From: Tai, Tom
Sent: Monday, April 04, 2011 4:02 PM
To: Price, John E
Cc: STPCOL; Wunder, George; Tonacci, Mark
Subject: Wed Call - Clarification on March 14 2011 Audit Actions
Attachments: Clarification on March 14 2011 Audit Actions.docx

Issue 1 (Audit Action 3.7-7): Revise Appendix 3A and 3H.6 to reconcile ground water elevation with Chapter 2

Issue 8: Stability Analysis Procedure

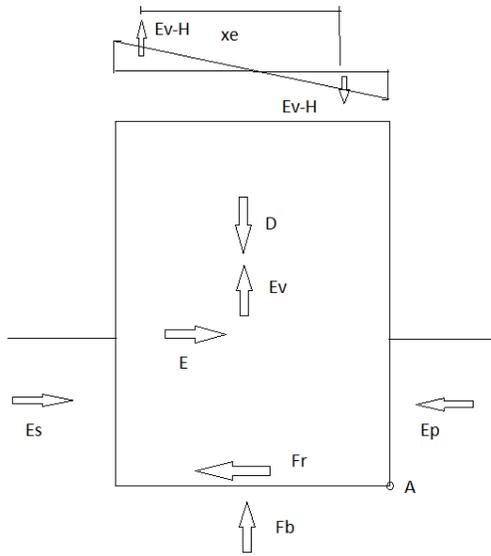
A brief presentation of the stability analysis procedure was made by the applicant during the March 14, 2011 audit. The presentation included a rigid body diagram showing the forces acting on the structure for stability calculations. The applicant indicated that the total seismic demand is calculated by summing all the inertia forces and moments acting on the structure. These inertia forces are calculated by multiplying the mass of each node by the absolute value of the maximum acceleration response at that node obtained from the SSI analysis. The calculation of the seismic overturning moment is based on the horizontal seismic load E and vertical seismic load E_v about tipping point A, as shown in the figure below. The moment due to horizontal earthquake does not include E_{v-H} (vertical force due to horizontal input) which also produces overturning moment about A. The applicant is requested to provide justification for not including the vertical component of response due to horizontal seismic input in calculating the foundation overturning moment.
